ADDENDUM NO. 4
Appoquinimink School District
Silver Lake Elementary School
Additions and Renovations – Bid Package 'A'
Page 1

January 10, 2019

The contract documents for the above referenced project, dated December 6, 2019 are amended as follows:

GI / GR

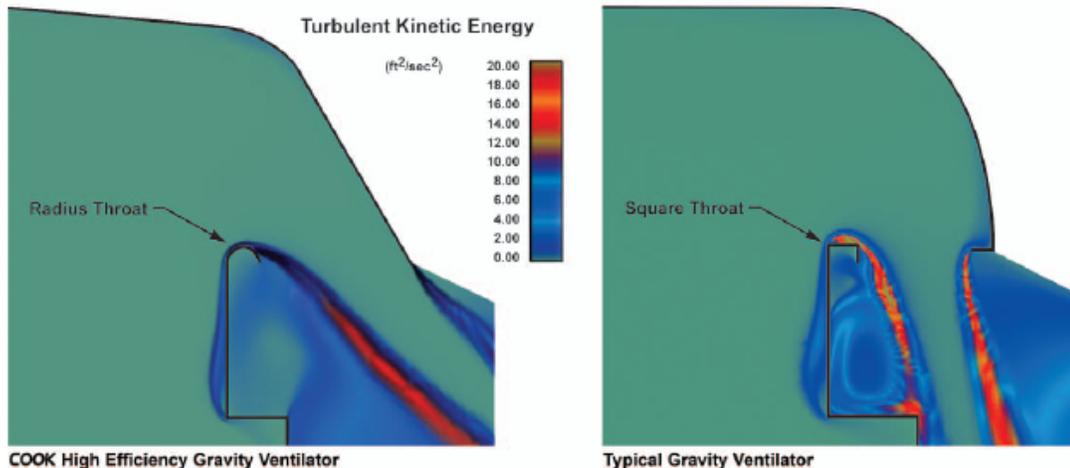
Drawing A40.1 showing mechanical units sloped, is this correct? Or will roof curbs be on the roof slope?

- 1.) Yes, they will be sloped.
- 2.) They are Gravity Ventilation Units, over mechanical mezzanines.
- 3.) Refer to attached manufacturer's product sheet.
- 4.) Schedule over served units:
 - a. ERU-1: Area 'B' (West)
 - i. Intake Hood: 24"x54" throat / 54"x72" hood
 - ii. Exhaust Hood: 24"x42" throat / 34"x60" hood
 - b. ERU-2: Area 'B' (East)
 - i. Intake Hood: 24"x48" throat / 48"x72" hood
 - ii. Exhaust Hood: 24"x42" throat / 34"x60" hood
 - c. ERU-1: Area 'C'
 - i. Intake Hood: 24"x66" throat / 57"x84" hood
 - ii. Exhaust Hood: 24"x54" throat / 36"x72" hood
